SUBJECT: Submits addl info re electrical separation at facility,
 clarifying SSER 4 concerning fire wrap used as electrical
 separation barrier. Revised FSAR page clarifying types of
 wraps used encl.

SERIAL: NLS-86-437

SHEARON HARRIS NUCLEAR POWER PLANT
DOCKET NO. 50-400/LICENSE NO. NPF-53
ELECTRICAL SEPARATION

TYPICAL APPARENT THERMAL CONDUCTIVITY

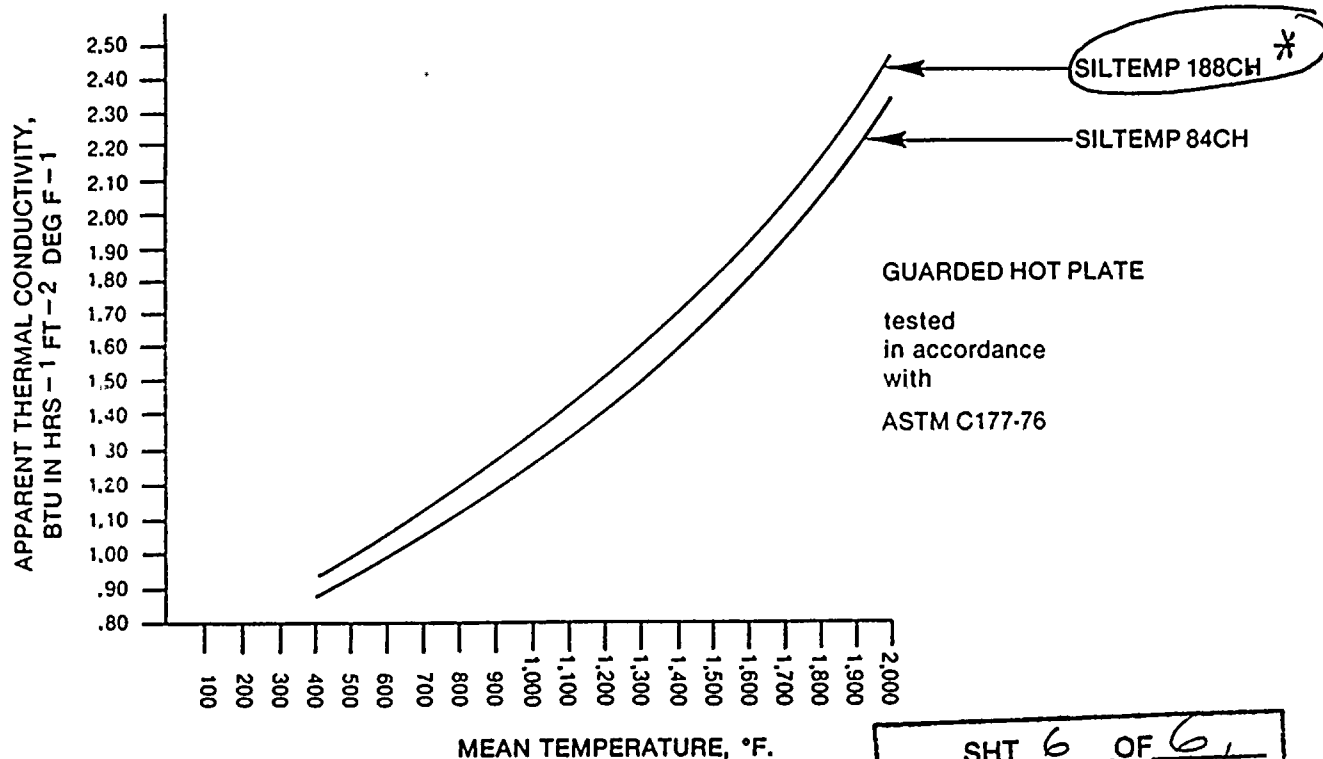
1. The containment of the fault circuit is the primary concern.
2. Per catalog information, Siltemp does not melt until temperatures exceed 3000°F, similar to steel (see Attachment A).
3. Thermal conductivity is superior to steel barrier material (see Attachment A).
4. The wrap technique utilized at SHNPP has been proof tested by Beaver Valley (PW-E wrap technique). From the Beaver Valley testing, it is shown that this wrap type performs the function similar to a steel conduit (see Attachment B).
